CHANGES FOR SECTION 96 APPROVAL

CLIENT:
DEE WHY RSL CLUB

PROJECT:
STAGE 5 - CLUB EXTENSION
PHASE 2 WORKS - SOUTHERN
CARPARK & ENCLOSURE

DRAWING TITLE:
CAR PARK LEVEL 1 (ENTRY LEVEL)
EXISTING AND DEMOLITION PLAN

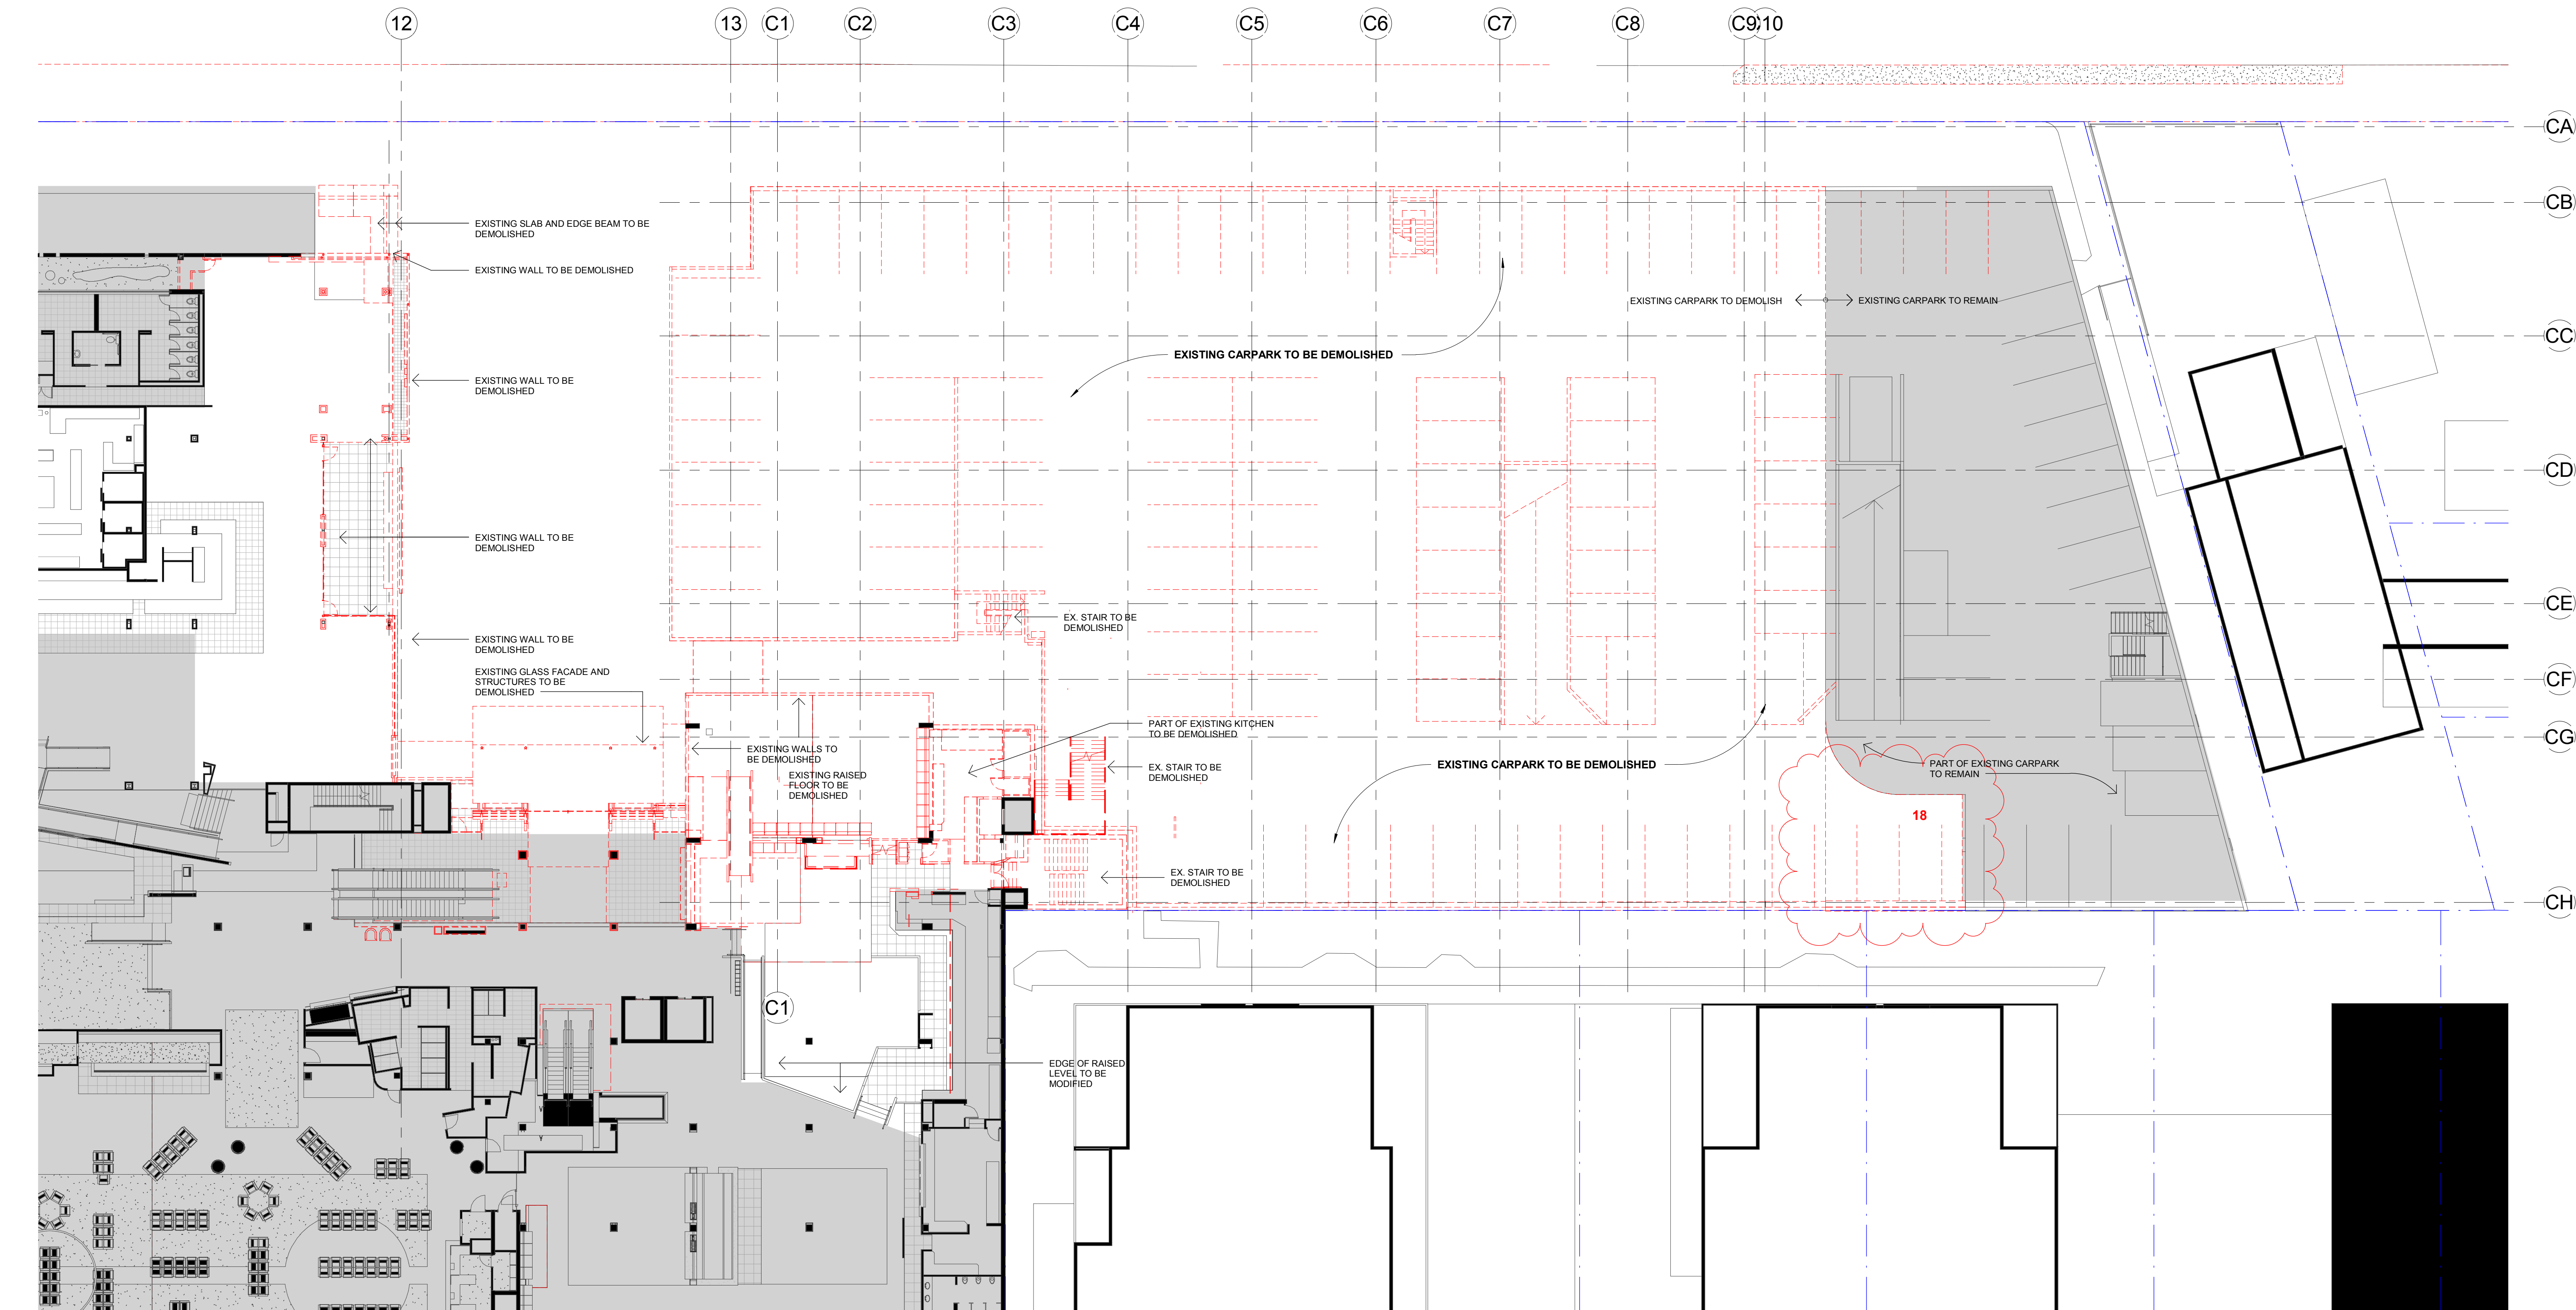
- ground/landscape/floor plate
18. REVISED LOADING DOCK ENTRANCE AND LOCATION/ ENLARGED DEMOLISHED AREA IN THE EXISTING RETAINED SOUTHERN CAR PARK
 19. NEW / MODIFIED EGRESS PATHS FROM EXISTING CARPARK LEVEL -1. NEW CARPARK LEVEL 1.

22. RELOCATED STORMWATER OVERFLOW PATH
 23. EXTENT OF BASEMENT CAR PARK LEVELS REDUCED. BASEMENT REDUCED BY 14394mm FROM THE WEST BOUNDARY. BASEMENT ENLARGED BY 280mm TOWARDS THE SOUTH BOUNDARY. CARPARK CHANGED FROM FLAT PLATE TO SPLIT LEVEL ON ALL LEVELS. DEPTH OF CAR PARK INCREASED FROM RL - 3.600 TO RL -5.700. OVERALL PARKING SPACES REDUCED FROM 687 TO 680

CAR PARK LEVEL 2 EXISTING AND DEMOLITION PLAN

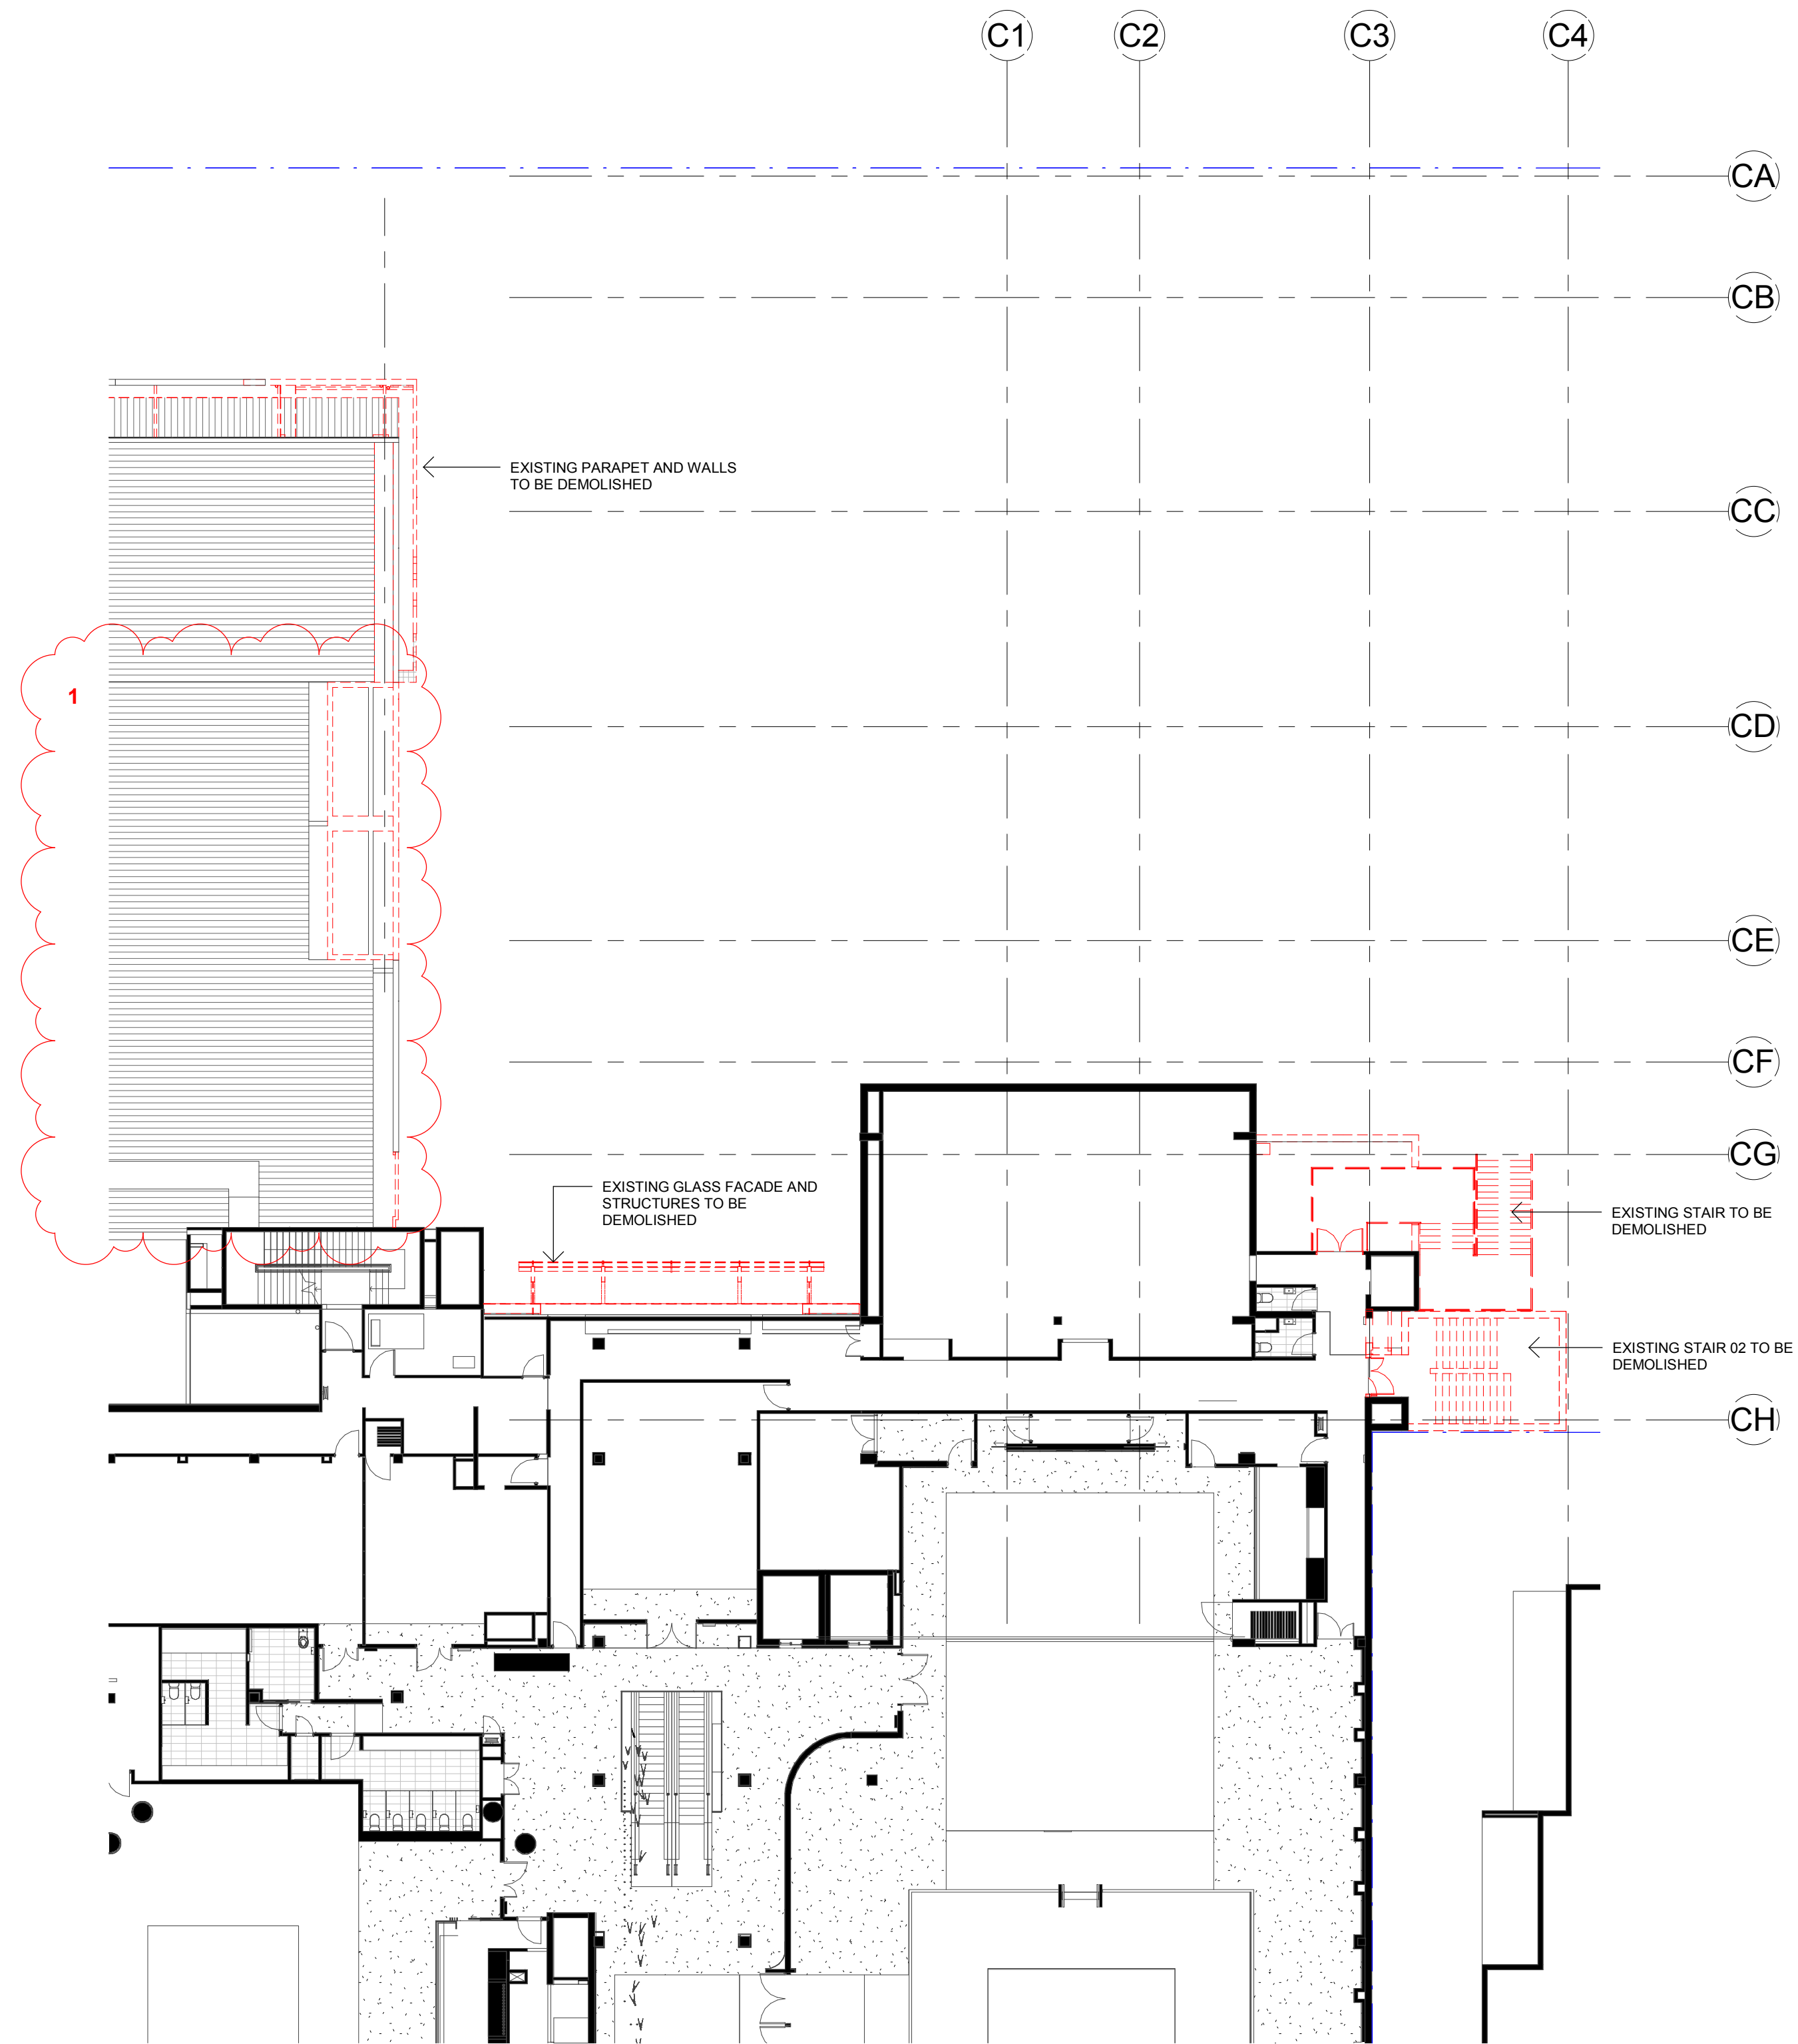
18. REVISED LOADING DOCK ENTRANCE AND LOCATION/ ENLARGED DEMOLISHED AREA IN THE EXISTING RETAINED SOUTHERN CAR PARK
19. NEW / MODIFIED EGRESS PATHS FROM EXISTING CARPARK LEVEL -1. NEW CARPARK LEVEL 1.
